Access Compliance Report

Public Rights-of-Way

(Curb Ramps)

Intersection ID: 14382	Main Street: BROOKHILL_RD	Cross Street: REMUS_RD	Location: S
ADA ID: 934CD9D58BE8	Ramp Type: PerpDiag	Initial Pass/Fail: Fail	Overall Compliance: No
Codes/Mitigation Info/Possible Solution		Field Measurements/Component Compliance	
Severity Score: 33.75

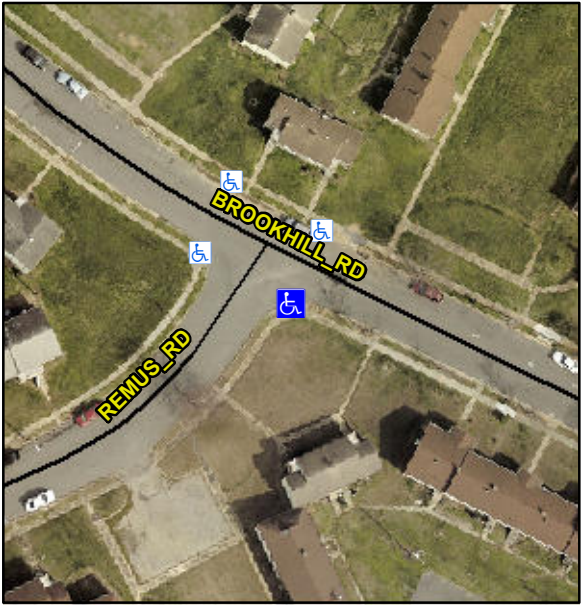
Possible Solutions:		Compliance	Description	Data	Compliance	Description	Data
	Remove & Replace Curb Ramp With Two New Directional Ramps or Equivalent.		N/A	Ramp Length (in)	86.0	Yes	Ramp Slope (%)	6.4
Surveyor Notes: N/A PROW/ADA: Not Found, R304.5.1, R304.5.3			No	Ramp Width (in)	43.0	No	Ramp XSlope (%)	9.0
			N/A	Flare Type LT	N/A	N/A	Flare Type RT	N/A
			N/A	Flare Slope LT (%)	N/A	N/A	Flare Slope RT (%)	N/A
			N/A	Flare Traversable LT?	N/A	N/A	Flare Traversable RT?	N/A
			N/A	Landing Length (in)	N/A	N/A	DWS Provided?	N/A
			N/A	Landing Width (in)	N/A	N/A	DWS Contrast?	N/A
			N/A	Landing Slope (%)	N/A	N/A	DWS Length (in)	N/A
			N/A	Landing X Slope (%)	N/A	N/A	DWS Full Width?	N/A
			N/A	Landing Curb? (Y/N)	N/A	N/A	DWS Offset (in)	N/A
			N/A	Shared Landing?	N/A			
			N/A	Gutter Ponding?	N/A	N/A	Gutter Slope (%)	N/A
			N/A	Gutter Lip Ht (in)	N/A	N/A	Gutter X Slope (%)	N/A
			N/A	Painted X Walk1?	No	N/A	Painted X Walk2?	No

X Walk 1 Direction	To NE		X Walk 2 Direction	To NW
			N/A	X Walk 1 Width (in)	N/A	N/A	X Walk 2 Width (in)	N/A
				X Walk 1 Slope (%)	5.9		X Walk 2 Slope (%)	1.2
				X Walk 1 X Slope (%)	3.3		X Walk 2 X Slope (%)	8.9
			N/A	Ramp inside XWalk1?	N/A	N/A	Ramp inside XWalk2?	N/A
				Road Slope (%)	6.5	N/A	Clear Space?	N/A
				Road X Slope (%)	5.0	N/A	Clear Space to XWalk (in)	N/A
			N/A	Any Obstructions?	N/A	N/A	Storm Grate/Utility Hazard?	N/A
				Obstruction Type			Storm Grate/Utility Type	
						N/A		N/A
						Yes	Surface Condition? (G/P)	Good
